Service Letter

SL07-474/JJP
March 2007

**Lifting Tool for Crosshead Bearing Cap
80-98MC/MC-C and ME/ME-C Engines**
Action Code: IMMEDIATELY

Fig. 1: Lifting tool for K98MC-C

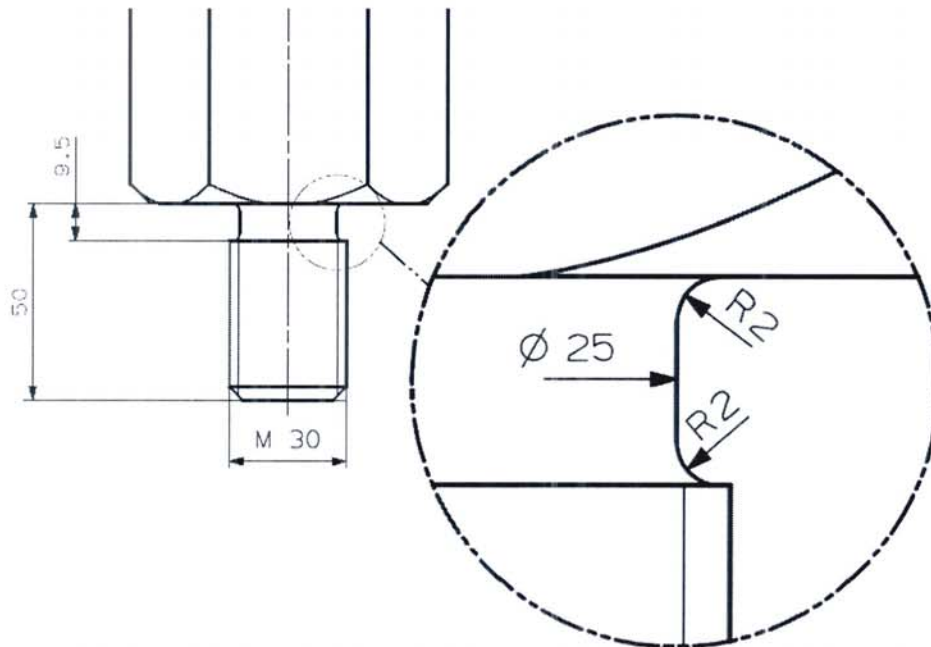
The stud has not been made from adequate material and, equally important, it appears not to have been machined as specified. One important fillet was smaller than specified. Furthermore, the thread tap on the extension tool seems to have been pre-bent from an earlier lift.

We recommend engine crews to check the fillets on the lifting tools, see Fig 1.

If an insufficient fillet or signs of cracks, bending or other misuse is found, we strongly recommend to discard the extension stud and order a new one, either from the engine builder or from MAN Diesel A/S, PrimeServ in Copenhagen.
